# UNITED STATES PATENT AND TRADEMARK OFFICE

APPLICATION NO.	FILING DATE	FIRST NAMED INVENTOR	ATTORNEY DOCKET NO.	CONFIRMATION NO.
09/885,626	06/20/2001	Hans Bruggemann	10537/126	4532

<b>Office Action Summary</b>	Application No. 09/885,626	Applicant(s) BRUGGEMANN ET AL.	
	Examiner Tu M. Nguyen	Art Unit 3748

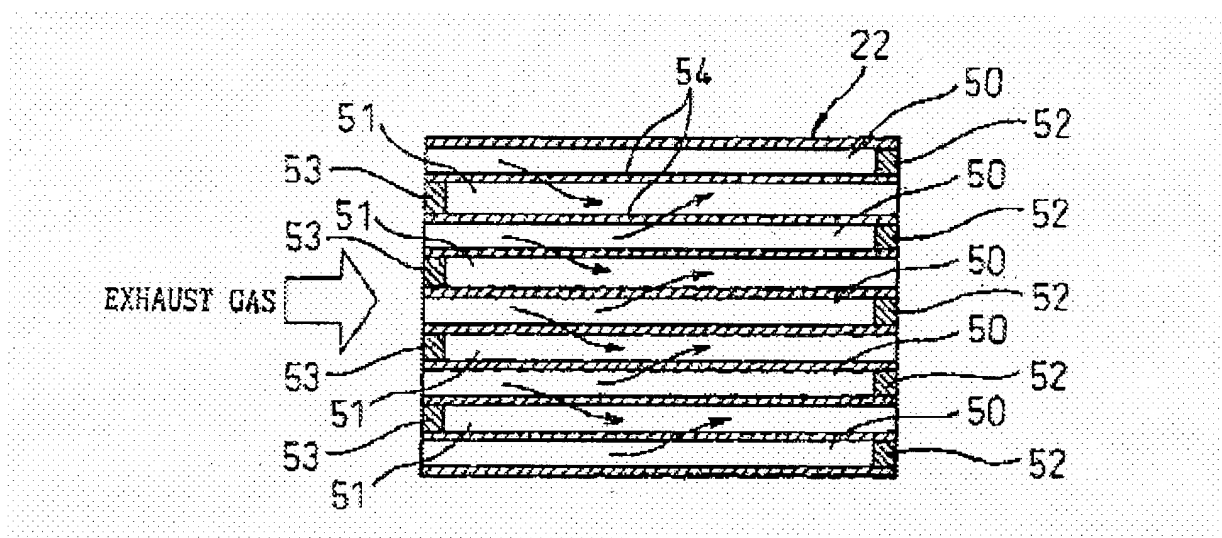
As shown in Figure 9, Araki et al. disclose a particulate filter (93) having a dual function of trapping particulate matters and of absorbing and releasing SO<sub>x</sub> in the exhaust gas. As indicated on lines 39-59 of column 15, the particulate filter (93) has numerous exhaust gas

passages formed in parallel. This can be better illustrated by the figure shown below where the exhaust gas passages are labeled as "50" and "51". Approximately half of the passages are plugged at the upstream ends and the other half are plugged at the downstream ends. The exhaust gas flows into the filter through the passages having open upstream ends, and flows into the passages having downstream ends through the porous walls separating the exhaust gas passages from each other.

The particulate matters such as soot are trapped or collected by the porous walls (labeled as "54" in the above figure) of the filter. As aforementioned, the particulate filter (93) also has a function to absorb SOx. The porous walls of the filter (93) are coated with layers of alumina, silica, or titania adapted to absorb SOx in the exhaust gas. Since the exhaust gas in Araki et al. has to flow through the layers of alumina, silica, or titania first before flowing through the porous walls, it is clear that these layers are located at an upstream location from the porous walls of the particulate filter. The SOx in the exhaust gas is absorbed by these layers first and then the exhaust gas depleted of SOx can flow through the porous walls where the soot particles are

collected therein. Thus, Araki et al. clearly disclose "an arrangement (layers of alumina, silica, or titania) disposed upstream from the particle filter and configured to at least reduce clogging of the particle filter by prevention of development of sulfate ash upstream from the particle filter".
